## SERVICE BULLETIN

POWER PLANT - NACELLE - POWERPLANT - GEARBOX BREATHER OUTLET DUCT - REPLACEMENT OF -  
CATEGORY CODE 5 - MOD.NAC-71-0128

# V2500-NAC-71-0128

REPLACEMENT OF THE GEARBOX BREATHER OUTLET DUCT  
Fig.1

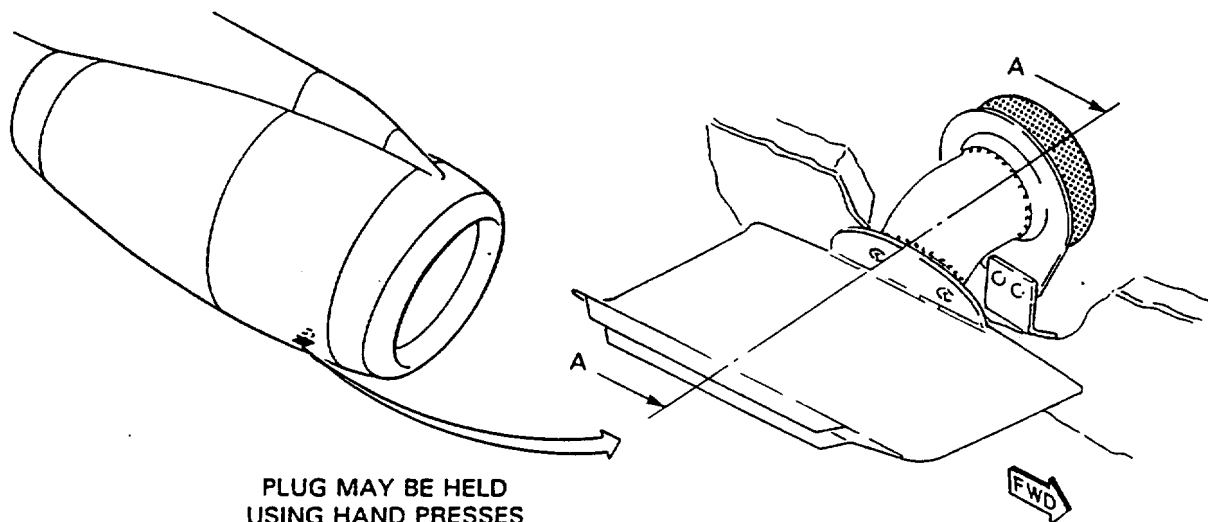
Introduction of the gearbox breather vent may cause an oil well to form between it and the breather outlet duct. Trapped oil may then leak and cause staining of the fan cowl door.

- (a) The gearbox breather vent, together with associated bolts, nuts and washers are temporarily removed from the fan cowl door. the breather outlet duct is drilled off and replaced with an improved duct. The gearbox vent is then installed back to the door.

- (1) Open the right hand fan cowl door with instructions in the A320/V2500 Engine Maintenance Manual, Task 71-13-00-010-010.
- (2) Find the gearbox breather outlet at the bottom, aft part of the right hand fan cowl door. Refer to figure 1.

- (1) Remove and retain four NAS7203U-3 bolts, four AN960-C101 washers and four H01-3 nuts to release the gearbox vent. Retain the gearbox vent also. Refer to figure 1.
- (2) Remove the HL11VF-6-4 Hi-lok bolt and HL97V-6 Hi-lok collar from the outlet duct. Discard the Hi-lok collar.
- (3) Drill out two CR3523-5-2 rivets to release the outlet duct. Remove the outlet duct.

- (4) Clean the mating faces of the outlet duct with trichloroethylene solvent and leave to dry. Apply a liberal coat of PR1422B2 sealant to the mating faces.
- (5) Rivet the new outlet duct in position with two CR3523-5-2 rivets.
- (6) Install the HL11VF-6-4 Hi-lok bolt and safety with an AN960-C10L washer and H01-3 nut. Torque the nut to 40 lbf in.(4.522 Nm).
- (7) Install the gearbox vent back in position with five NAS7203U-3 bolts, four AN960-C10L washers and four H01-3 nuts. Torque bolts to 40 lbf in (4.52Nm).
- (8) Remove any unwanted sealant with a clean rag and leave to cure in accordance with the manufacturers recommendations.

LEAK TEST  
Fig.2

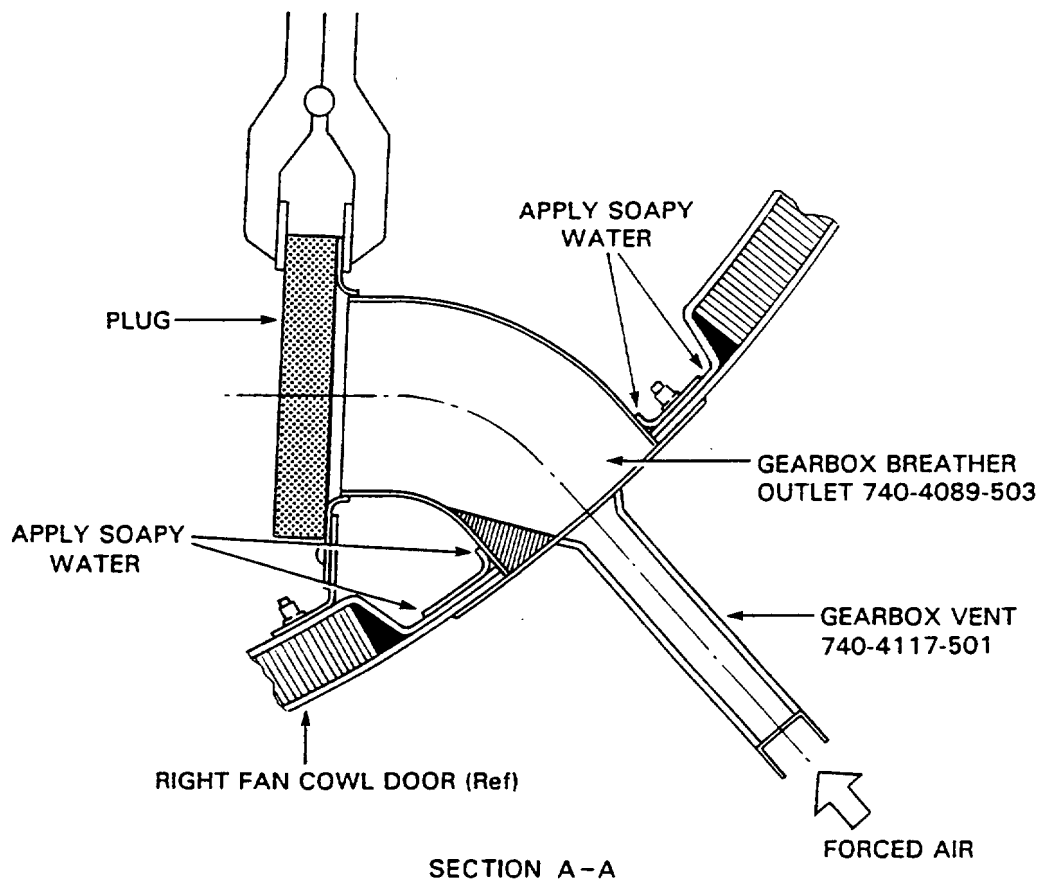
- (1) Do a pressure test of the gearbox breather outlet duct as follows (Refer to Figure 2):

- (a) Make a plug equal to the diameter of the outlet duct from 0.25 in.(6mm) thick (approximate) silicone rubber sheet.
  - (b) Put the plug on the end of the gearbox breather outlet duct (GBOD) as shown. Use hand presses as necessary to provide an effective seal.
  - (c) Put soapy water around the sealed edge of the GBOD as shown.
  - (d) Blow forced air through the gearbox vent and examine for leaks around the sealed edge of the GBOD.
  - (e) If air leaks are found, remove the GBOD and apply sealant again with instructions in step 2.B.
- (2) Close the right fan cowl door with instructions in the A320/V2500 Aircraft Maintenance Manual, Task 71-13-00-410-010.
